**Board of Commissioners
Agenda Packet**

Agenda Item Title: PB 19-20 Flora Farm: Rezone 224.44 acres from Agricultural (AG) to Planned Development-Residential (PD-R) for property located in Moyock immediately south of Eagle Creek subdivision and Moyock Middle School. The request includes 285 single-family dwelling lots, up to 100,000 sf commercial, 125 upper story dwelling units, and a 22 acre school site

**STAFF REPORT
PB 19-20 FLORA FARM
REZONING
PLANNED DEVELOPMENT-
RESIDENTIAL
BOARD OF COMMISSIONERS
JUNE 22, 2020**

The illustration below depicts the TIA's recommended improvements noted above including an additional stoplight on Caratoke Highway (Survey Road and Fost Boulevard):

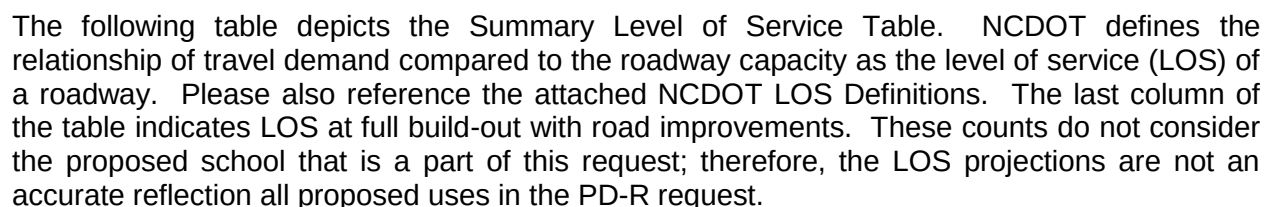
January 20, 2020 TIA and January 31, 2020 TIA: Routes all residential traffic through the future Fost Boulevard to Caratoke Highway in the adjoining development. The developer indicates that this is not correct, but a revised TIA has not been submitted. The TIA indicates that the future signalized intersection as part of the Fost Development can accommodate the additional traffic generated during the residential phase, and no signalizations or offsite lane geometric improvements are recommended. On March 25, 2020 the developer submitted a revised phasing plan indicating subdivision access to Survey Road as part of Phase 1.

- Connect both driveways to Survey Road with stop-controlled approaches as a full movement four-leg intersection.
- Construct Future Access #1 with one ingress lane and two egress lanes. Provide northbound left-turn lane with a minimum of 100 feet of full storage and appropriate taper and a through/right-turn lane. Lydia Street intersects with Future Access #1 approximately 300 feet from Survey Road, which provides the proper internal protected stem to accommodate projected queues. Typically, NCDOT requires a 100 foot minimum internal protected stem for this type of facility.

- Construct Future Access # 2 with one ingress lane and one egress lane.
- Provide an eastbound left-turn lane and right-turn lane along Survey Road, both with a minimum of 100 feet of full storage and appropriate taper.

- Provide a westbound left turn lane along Survey Road with at least 100 feet of full storage and appropriate taper.

**PRELIMINARY STORMWATER
MANAGEMENT PLAN**

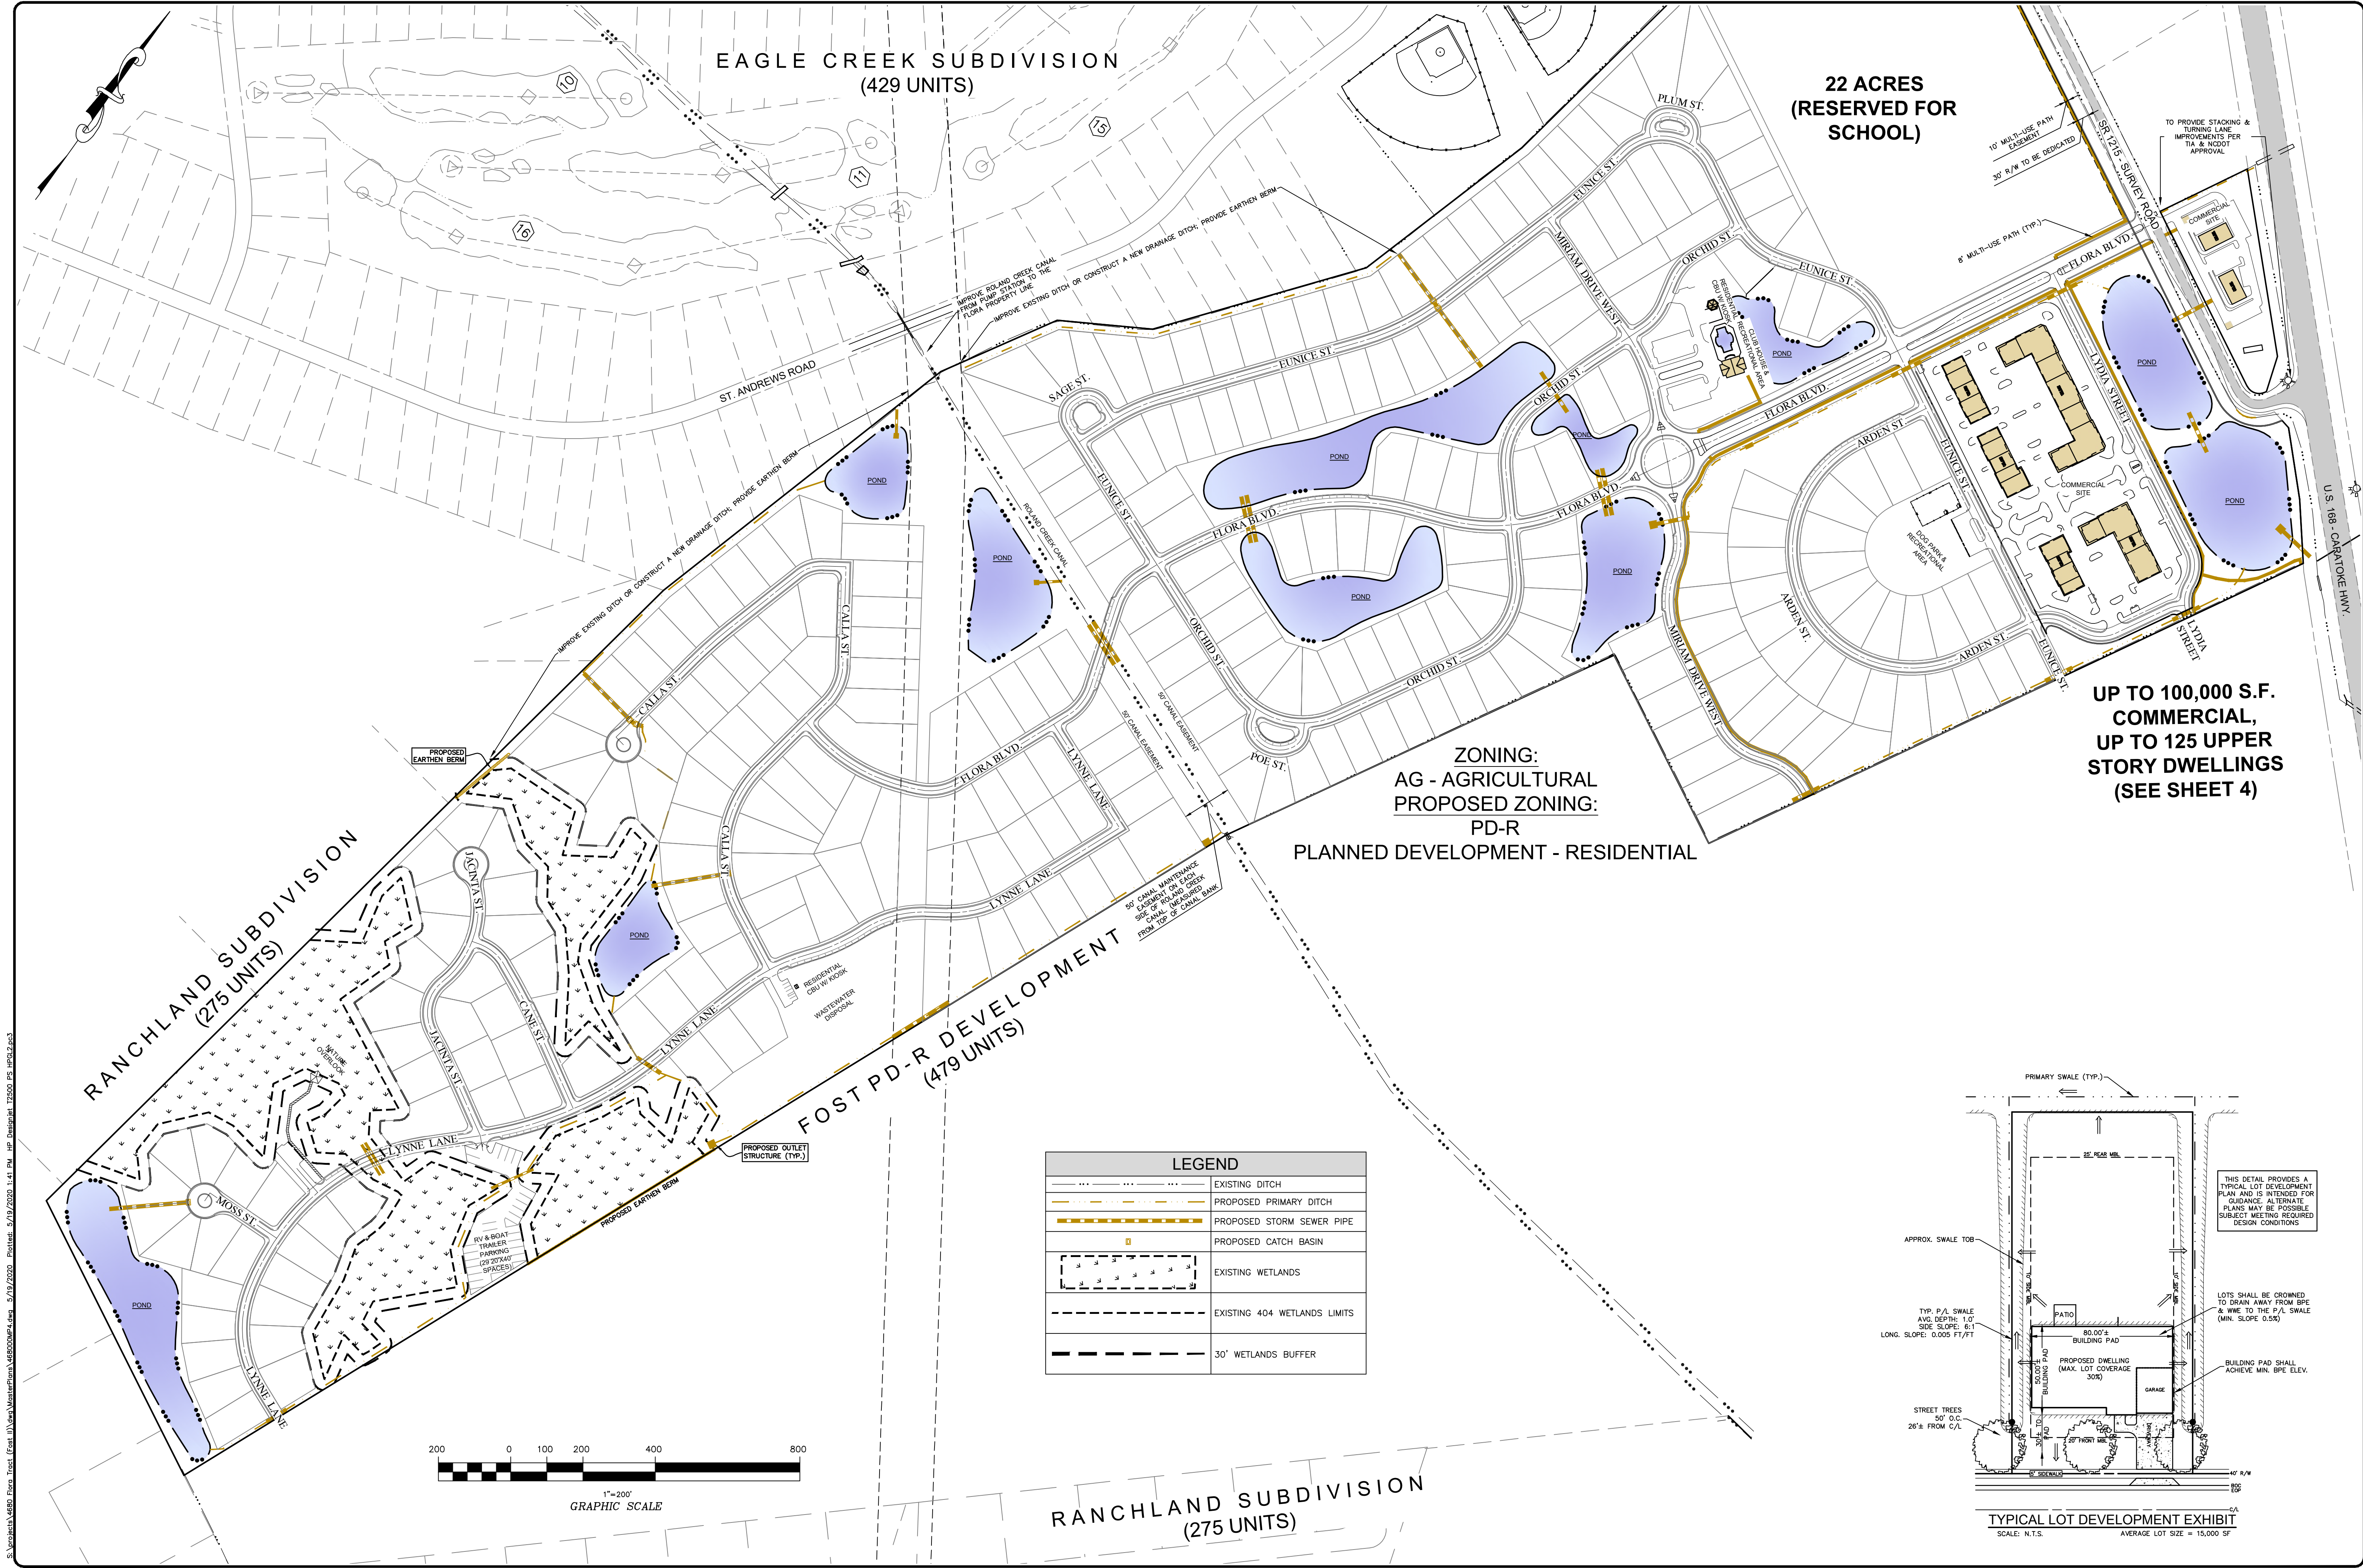
There is an emphasis on downstream maintenance at this time. There are portions of Rowland Creek and the ditches on Guinea Road and Survey Road with brush and debris that need to be cleaned up. The conceptual plan provides limited drainage details.

- i. Continue the Rowland Creek improvements to the northwest to Eagle Creek pump station as authorized by the Eagle Creek Homeowners Association.
 - ii. Improve the existing property line ditch or install a new ditch along a portion of the Property's northwestern common boundary line with Eagle Creek and Ranchland where shown on the Preliminary Drainage Plan on a positive grade with 3:1 side slopes and sized for a 100 year storm event from the drainage basin in which the Property and a portion of Eagle Creek and Ranchland Subdivision are located.

- v. Improvements will be generally as shown on sheet 5 of the Master Plan drawing.
2. General Stormwater Conditions
 - i. The Developer shall construct berms along ditch outlets against Eagle Creek and Ranchland to reduce the potential of the proposed development's runoff from flooding Eagle Creek and Ranchland during a 100 year storm.

Improvements will be generally as shown on sheet 5 of the Master Plan drawings
